Subject: N192286190 - Service Update
Fuel Leak Due to Accelerated Corrosion

Models: 2020 Chevrolet Silverado 2500/3500
2020 GMC Sierra 2500/3500
Equipped with 6.6L Diesel Engine (RPO L5P)

N192286190 Fuel Leak Due to Accelerated Corrosion

5515750

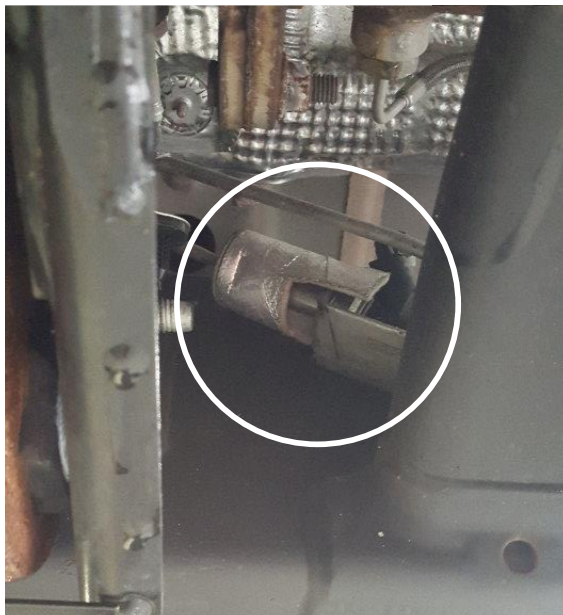
Condition	Certain 2020 model year Chevrolet Silverado 2500/3500 and GMC Sierra 2500/3500 vehicles may have a condition where the thermal cover may accelerate corrosion of the low pressure diesel hydrocarbon injector.
Correction	Dealers are to remove the low pressure diesel hydrocarbon injector thermal cover.

1. Lift the vehicle. Refer to *Lifting and Jacking the Vehicle* in SI.
2. Locate the hydrocarbon injector in the exhaust behind the torsion bar crossmember as shown.
3. Using wire cutters or tin snips, carefully cut the heat shield off the hydrocarbon injector and discard it.
4. Lower the vehicle. Refer to *Lifting and Jacking the Vehicle* in SI.
